Re: Minor Project Refinement No. 5 for the Round Mountain 500 kV Dynamic Reactive Support Project

Round Mountain 500 kilovolt (kV) Dynamic Reactive Support Fern Road Substation Project CPUC Minor Project Refinement Form

ATTACHMENT B
MPR-5 Figure

FERN ROAD SUBSTATION
MPR-5
Shasta County, CA

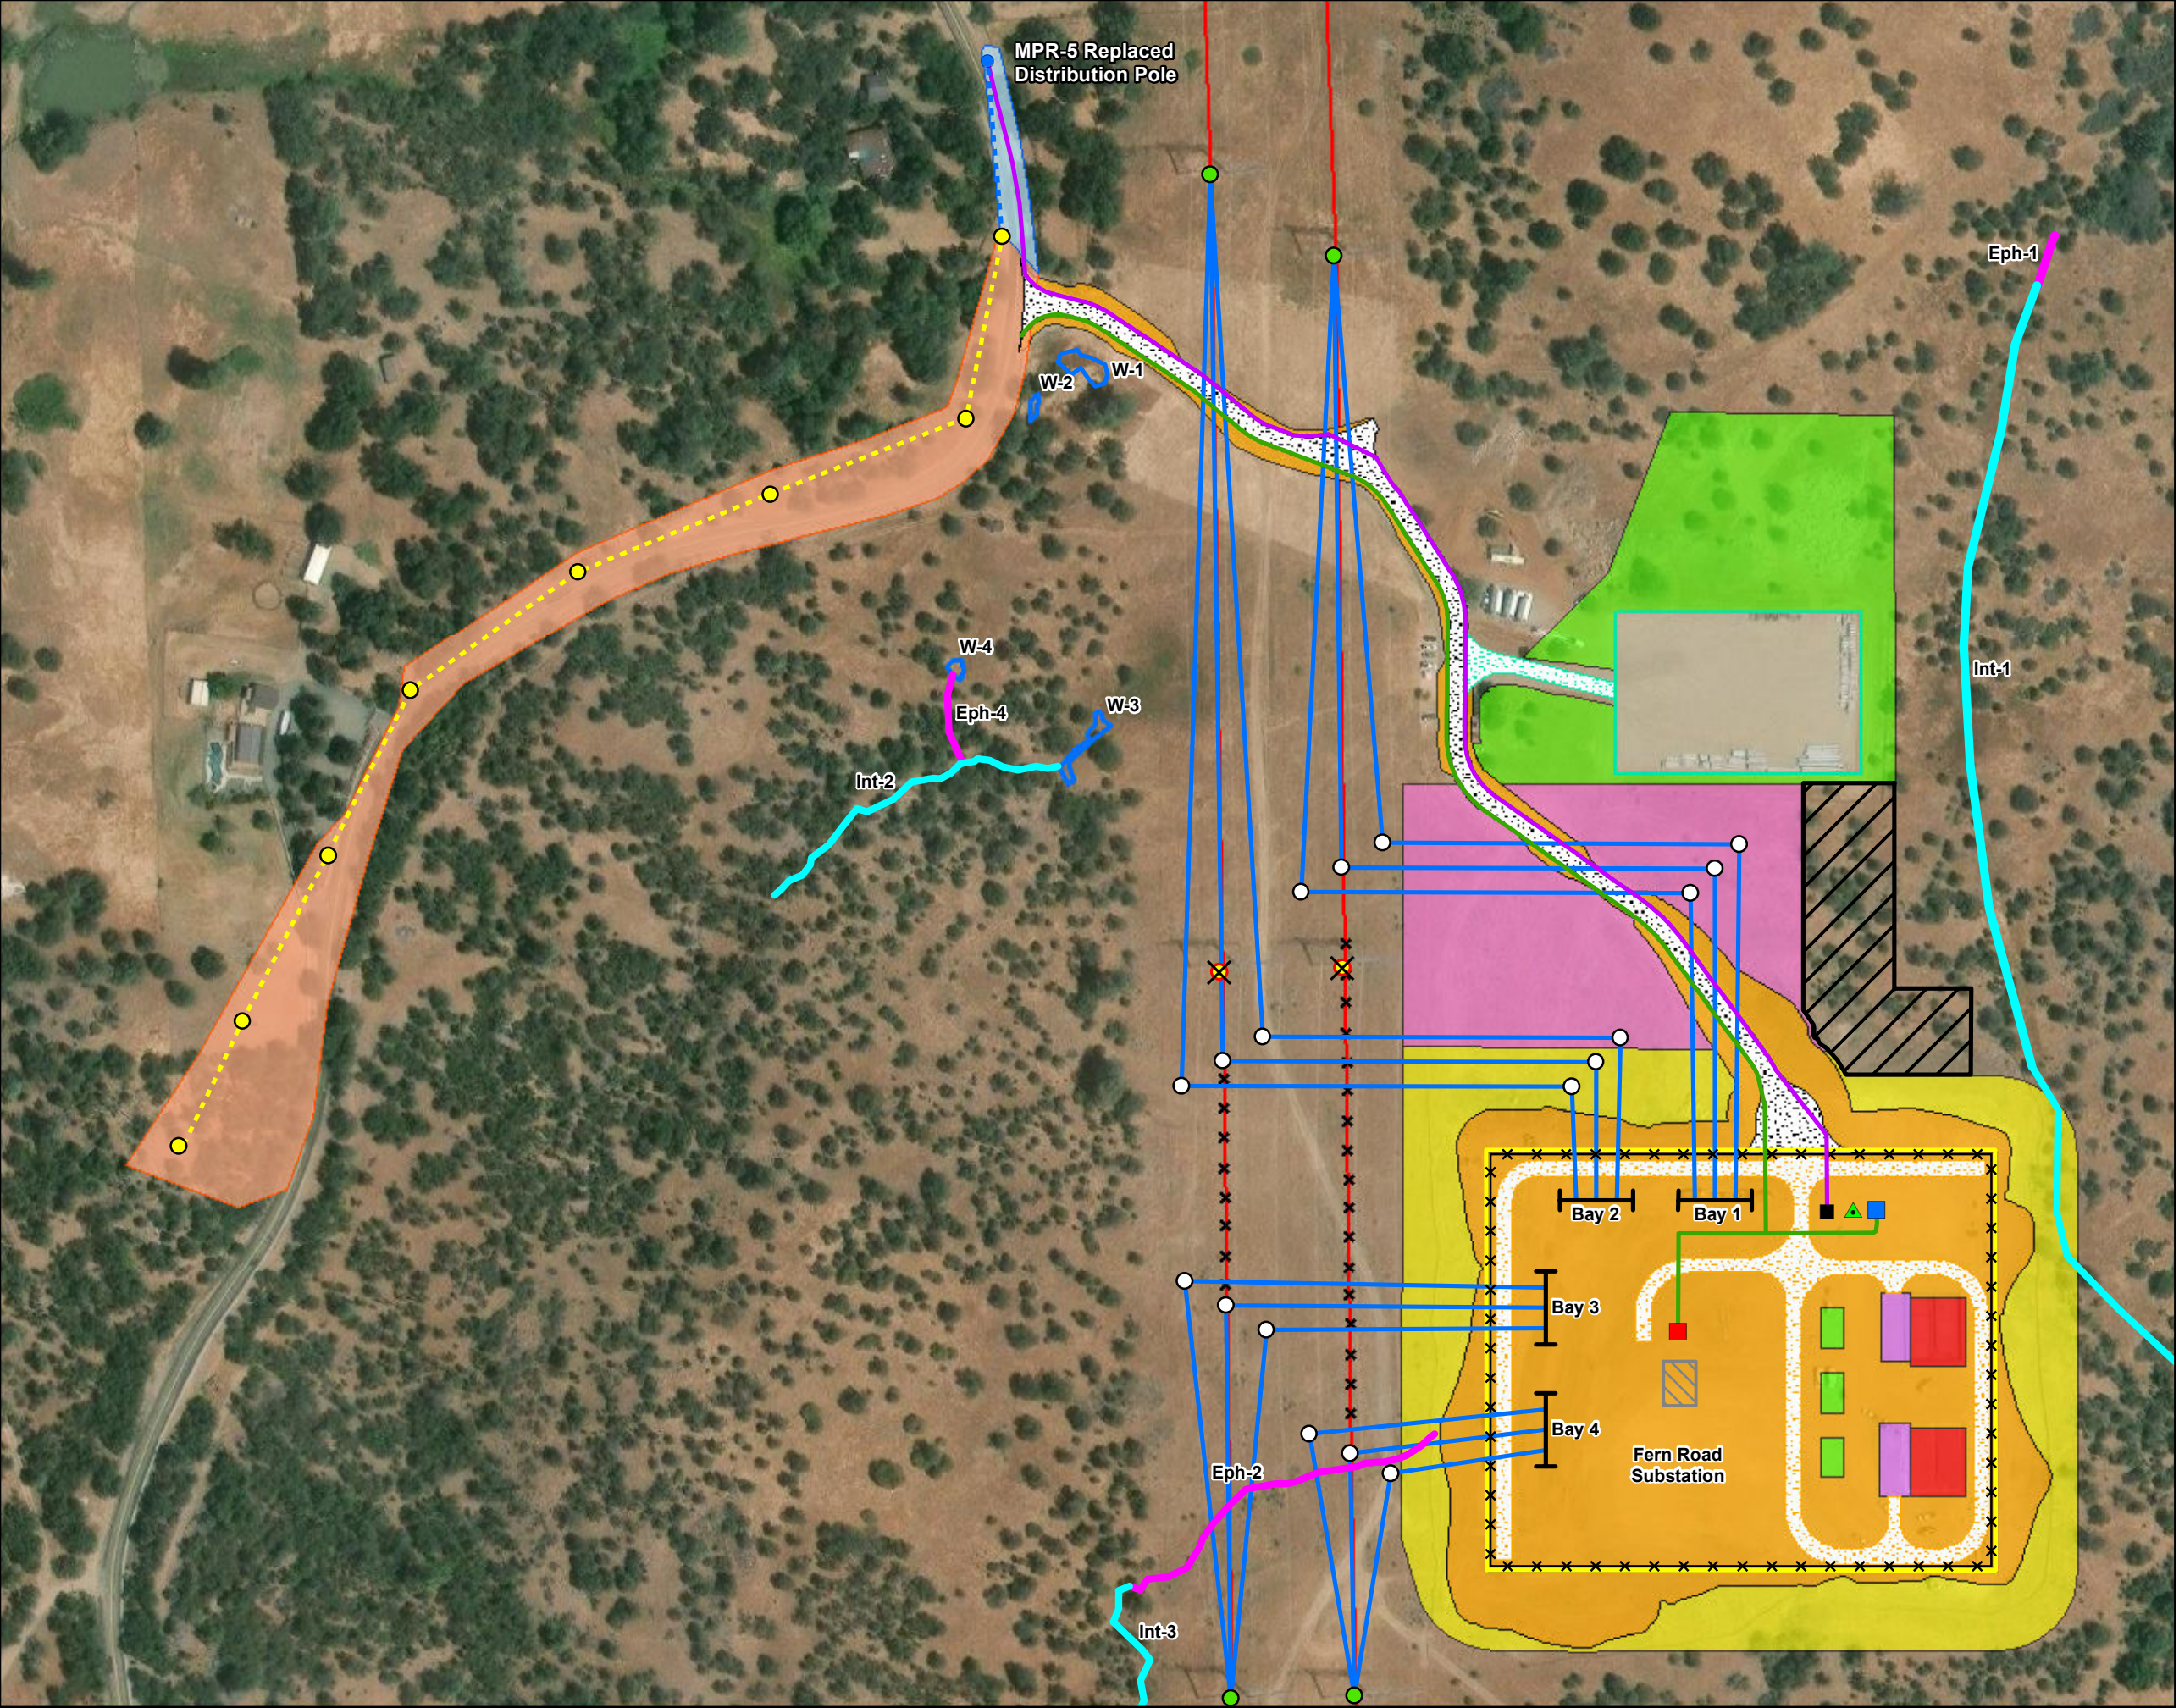
LSPGC is requesting approval of MPR-5 to install approximately 1,900 feet of underground 12 kilovolt (kV) distribution and approximately 1,650 feet of underground telecommunications for the Round Mountain 500 kV Dynamic Reactive Support Project (Fern Road Substation or Project), as described below and shown in **Attachment B, MPR-5 Figure**. In addition, one additional existing PG&E distribution pole would be replaced, and a substation mapping update is included as described below.

- **Underground 12 kV Distribution:** As discussed in Section 2.6.3 of the Final Initial Study / Mitigated Negative Declaration (IS/MND), an electric distribution line will be installed along the Project's existing access road to provide power for Fern Road Substation facilities from the existing PG&E distribution line that runs parallel to Fern Road. This 12 kV distribution line was originally proposed as an overhead line on approximately 35 wood poles; however, this is now being proposed as a 1,900-foot long underground line,

- **Distribution Pole Replacement on Fern Road:** As discussed in Section 2.6.3 of the Final IS/MND, the Project requires distribution modifications for eight poles along PG&E's existing distribution line on the west side of Fern Road which includes replacing the existing poles and converting them from a single-phase 12 kV to a three-phase 12 kV. It was assumed that the overhead distribution line that would connect into the Fern Road Substation would tap into the eighth, northernmost pole, located immediately west of the Project site entrance. As the 12 kV distribution line will now be underground, a ninth pole will need to be replaced on the east side of Fern Road, north of the site entrance, to avoid trenching across Fern Road (see **Attachment B, MPR-5 Figure**). The new wood pole will be replaced in the same location as the existing pole and will be approximately the same height (40 feet). The new three-phase pole will allow for a larger crossarm to connect the phases to the underground distribution line. The existing down guy wire will also be replaced to reinforce and strengthen the wire. As a result of the additional new pole, an additional 200 feet of overhead reconductoring will be performed by PG&E. This portion of the scope of the MPR-5 request is related the PG&E Facilities (Section 2.6) component of the Approved Project. A truck-mounted auger and crane would be utilized for pole replacement. An encroachment permit will be obtained from Shasta County by PG&E for the overhead reconductoring and pole replacement work.

- **Underground Telecommunications:** MPR-5 activities would include the installation of a 1,650-foot long underground fiber optic telecommunications line along the southern edge of the existing Fern Road Substation access road. This would require two, four-inch conduits to be installed within the same duct package. The line would be installed from the point of interconnection with an existing Frontier telecommunications line just south of the access road entrance off Fern Road, and would continue southeast along the access road to the Fern Road Substation, where the line would split and terminate within the PG&E Communications Monitoring Building and the LSPGC GIS Control Enclosure. LSPGC plans to obtain an encroachment permit from Shasta County for installation of the fiber optic telecommunications line within County ROW.

- **Mapping Update:** There are a few substation components that were described and approved within the Final IS/MND, but their location was not yet determined within the substation footprint at the time of NTP-1 approval. As such, components such as the PG&E Communications Monitoring Building were not included in Project mapping. Therefore, an updated substation layout is included in **Attachment B, MPR-5 Figure**. This is included as a mapping correction/update only, as LSPGC is not proposing any new substation components or infrastructure beyond what was anticipated within the Final IS/MND. The components included on **Attachment B, MPR-5 Figure** were

There is no change in temporary or permanent impacts resulting from the distribution pole replacement itself as it will be installed in approximately the same location. However, the distribution overland travel area will need to be increased by approximately 8,500 square feet (see **Attachment B, MPR-5 Figure**) in order to facilitate the pole replacement and additional 200 feet of PG&E overhead reconductoring work.
